**Subject:** AHM\_T1\_Bus Gate Idli.com\_Kitchen Equipment sizes undulations

This is to bring to your attention that the below listed equipment's sizes are not mentioned in the layout as a result we are unable to measure the actual feasibility for these equipment.

**LAYOUT**

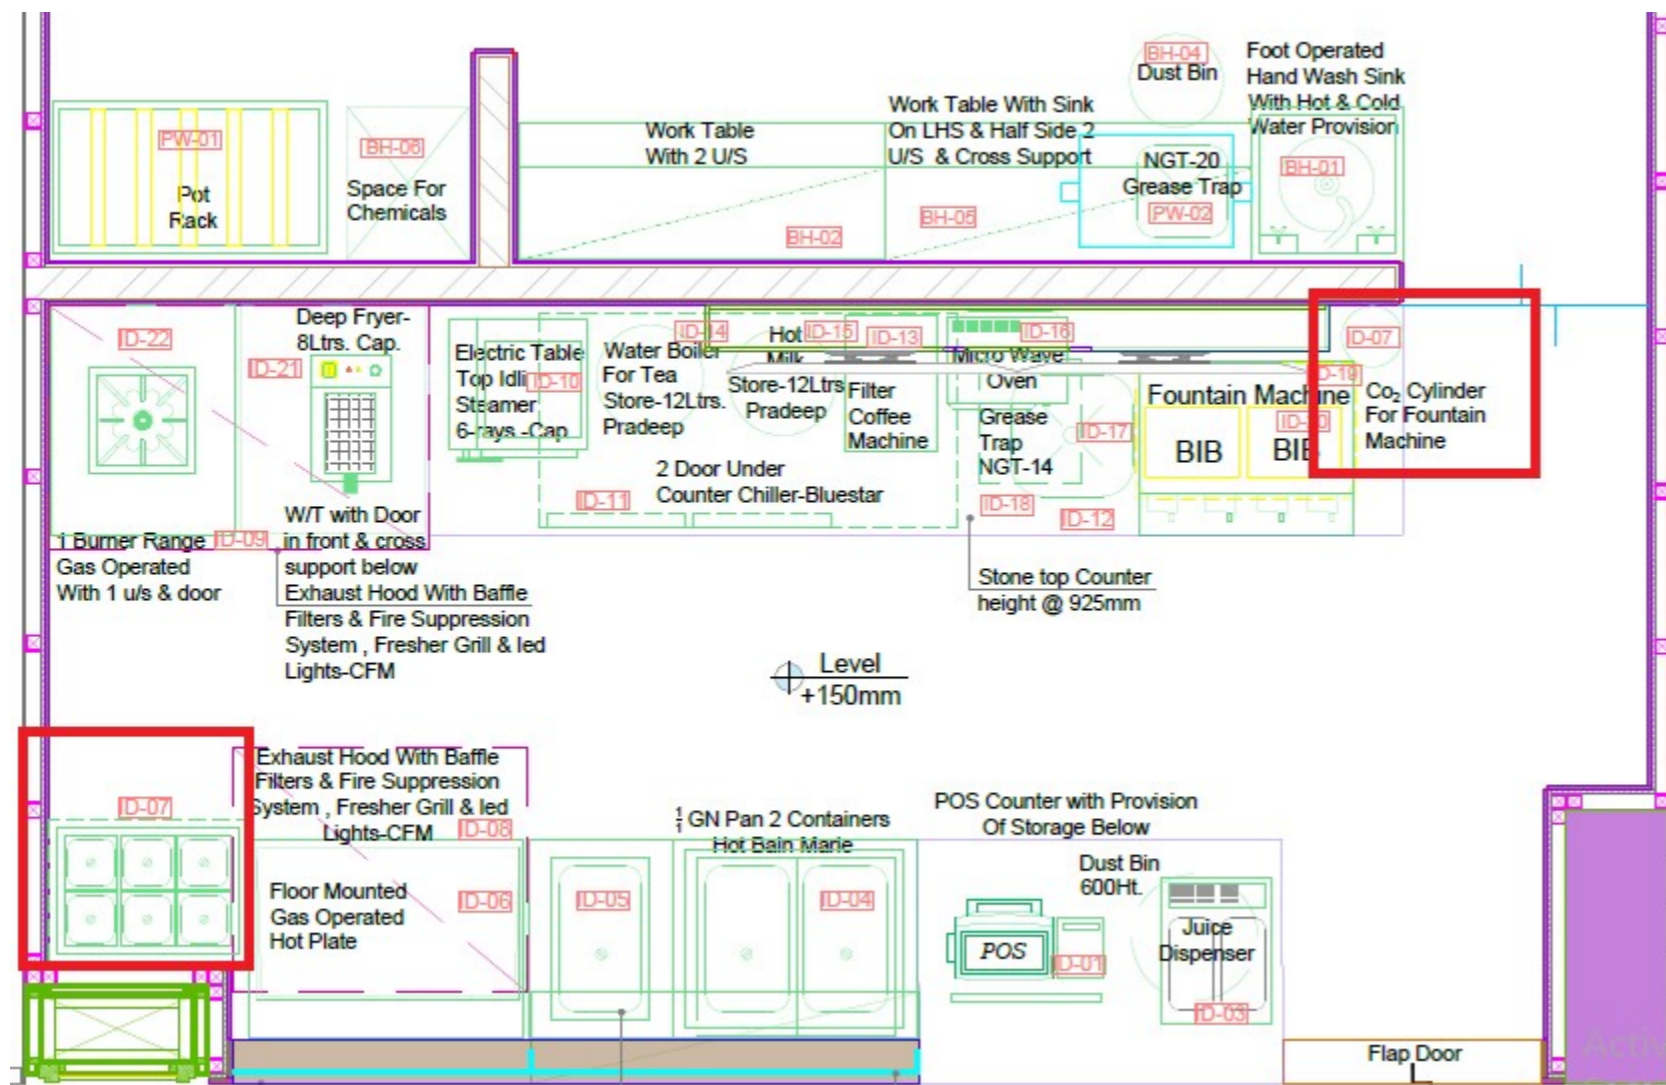
This is to bring to your attention that the equipment layout has indicated same number's equipment twice (i.e. **ID-07**) but the excel file has only one.

1. **ID-07 : Co2 Cylinder**
2. **ID-07 : Cold Bain Marie**

Request you to please refer the excel and equipment layout and kindly share the revised excel as per the layout at the earliest for ordering process.

1. ID-07 is Cold Bain Marie
2. ID-23 is Co2 Cylinder
